STAFF REPORT

RE: **a. Case No. 611-S-8**
 b. Case No. 14669-P-1
 c. Case No. 14669-P-2

REQUESTS: **a.** A request to amend the Midtown Plaza Area Plan to change the recommended land use from high-density residential to urban-density residential on about 1.2 acres generally located on the block bound by 45th St, 45th Ter, Wornall Rd and Broadway excluding the northwest and southeast corners of the block.

c. A request to approve a development plan on about 1.2 acres in District R-0.75 (Residential 0.75) to allow a residential development on the block bound by 45th St, 45th Ter, Wornall Rd and Broadway excluding the northwest and southeast corners of the block.

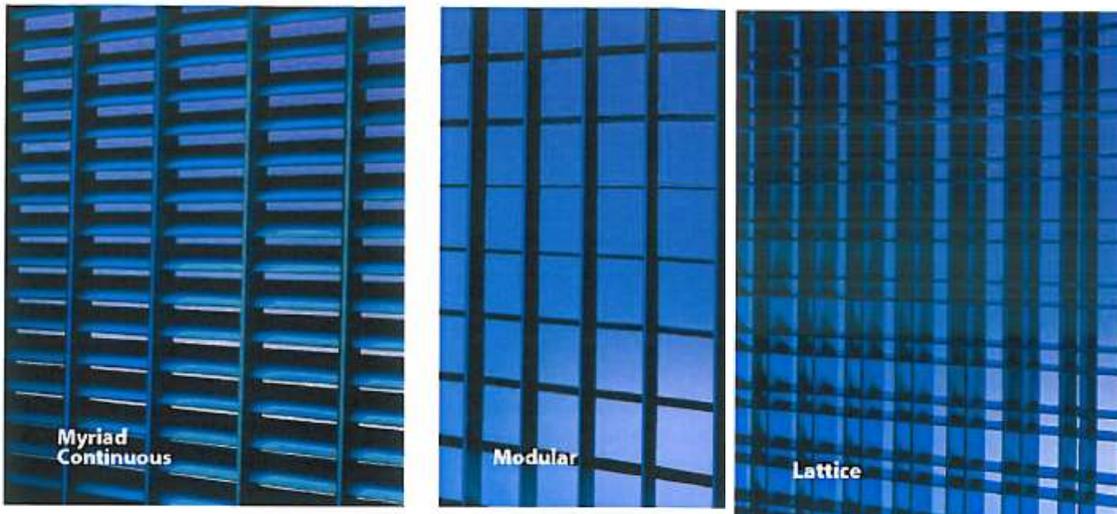
A sign plan has not been provided, however the elevations depict wall signs. Such signs are limited to 12 square feet in area and it appears the proposed signs exceed this. Plans should be revised to show signs which conform to this requirement.

- d. That a sidewalk is provided between Wornall Rd and the entrances on the east and northeast sides of the building.
 - e. That the signs are revised to conform with 88-445 and that a note is added stating that all signage is subject to a sign permit and shall conform to 88-445.
